**SUBDIVISION &
PLANNING APPROVAL STAFF REPORT****Date: February 01, 2018****NAME**

Eslava Creek Subdivision

Subdivision Approval to create two legal lots of record and Planning Approval to allow the construction of a new 140'± cell tower in a B-1, Buffer Business District.

SITE PLAN

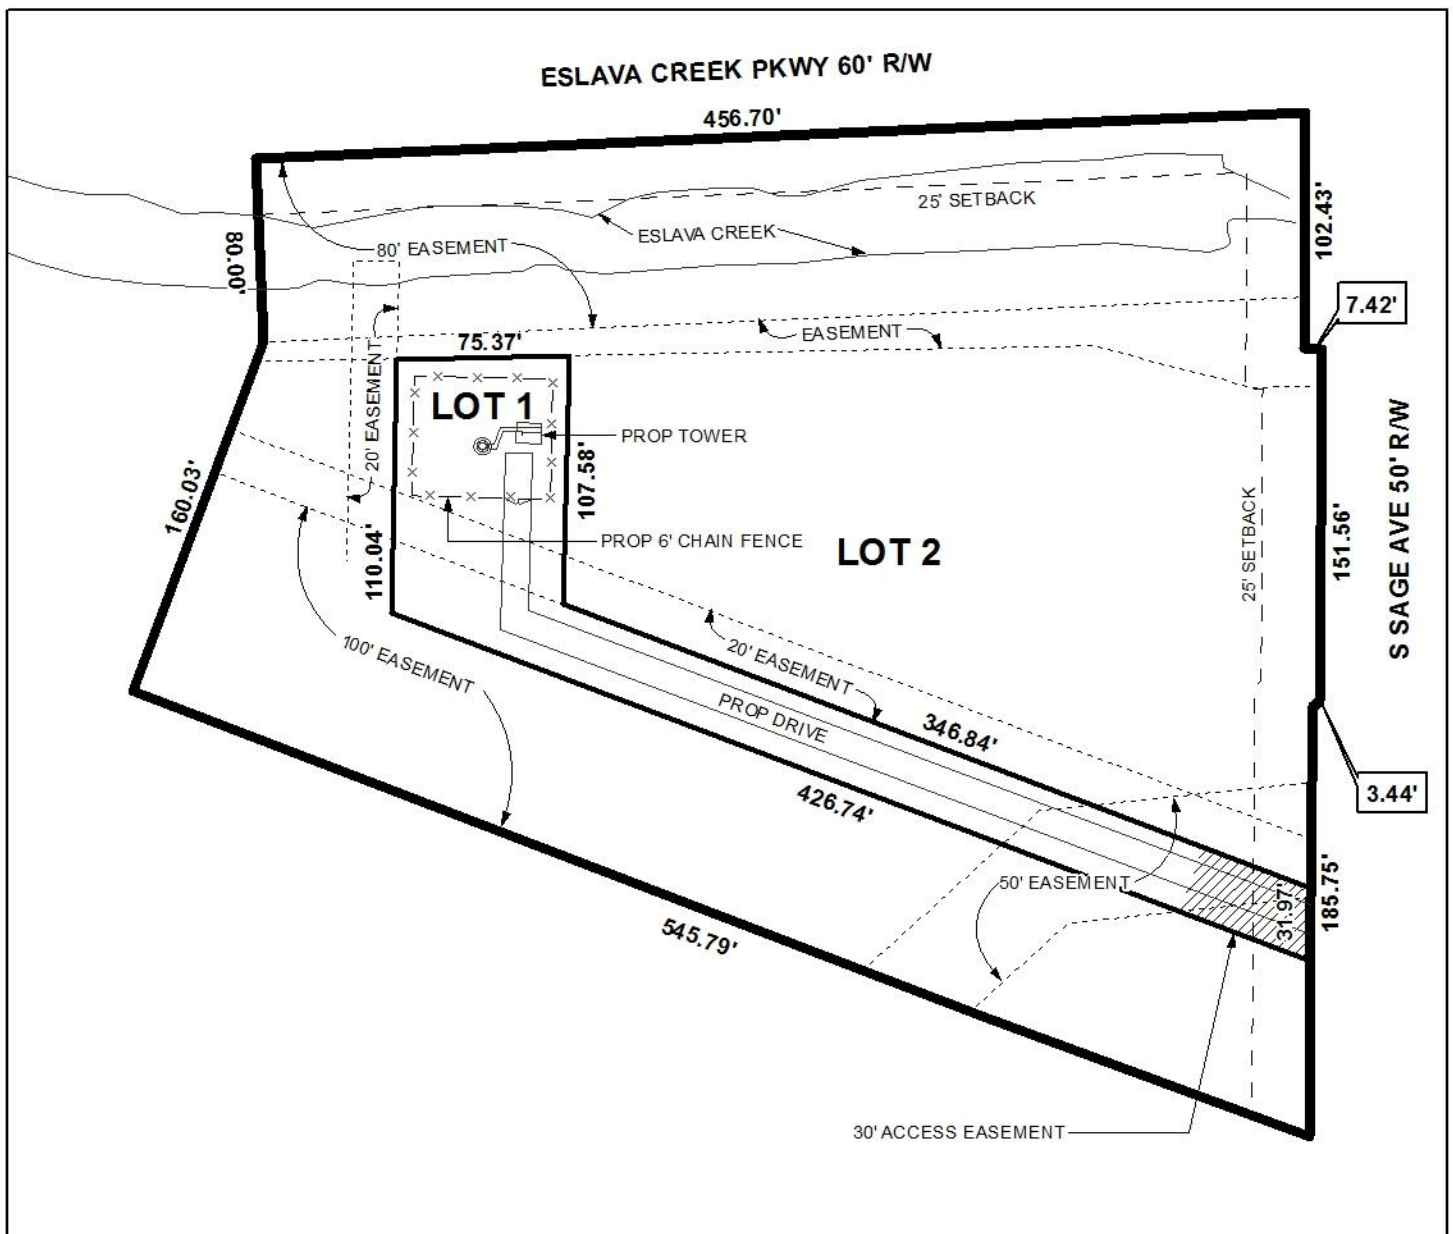
The site plan illustrates the proposed 140' monopole cellular telecommunications tower 30'± from the East and West property lines of the proposed lot, 35'± from the North property line, and 75'± from the South property line. Section 64-3.E.1. of the Zoning Ordinance limits the height of structures in B-1, Buffer Business Districts, to forty-five (45) feet, and Section 64-4.J.5.a.(2) requires that the setbacks on all sides of towers in B-1, Buffer Business Districts, be a distance equal to the height of the tower, hence the requested Height and Setback Variance requests.

A 6' chain link fence surrounding the tower facility is illustrated on the site plan along with a 12' wide access gate. Any changes to the layout and/or material of the fence or gate should be illustrated on a revised site plan and comply with Section 64-4.D.6. of the Zoning Ordinance.

Illumination is prohibited by Section 64-4.J.9. of the Zoning Ordinance unless required by the Federal Aviation Administration (FAA). A note on the site plan states that illumination is not required, and should therefore be retained on any revised site plan, if approved.

All towers and telecommunications facilities are required to be of camouflage design per Section 64-4.J.16. of the Zoning Ordinance. The applicant does not address this requirement, therefore it should be noted that, at a minimum, all towers not requiring FAA painting or marking shall have an exterior finish which is galvanized or painted a dull blue, gray, or black.

It should be noted that several labels and illustrations on the site plan are similar to those illustrated on the preliminary Subdivision plat. If approved, these labels and illustrations should be retained on the site plan, adjusted for any changes required on the Final Subdivision Plat.

- 1) the tower be limited to a monopole design;
- 2) approval of the Height and Setback Variance requests by the Board of Zoning Adjustment;

- 7) placement of a note on the site plan stating that Lot 2 is limited to no more than two (2) curb cuts to Eslava Creek Parkway, and that Lots 1 and 2 are limited to no more than two (2) shared curb cuts to Sage Avenue, with any changes in their sizes, locations, or designs to be approved by Traffic Engineering and conform to AASHTO standards, and Engineering approval for access to Eslava Creek Parkway;

- 8) retention of the 25' minimum building setback line along South Sage Avenue;
- 9) retention of all easements on the site plan;
- 10) placement of a note on the site plan stating no structures shall be constructed in any easement;
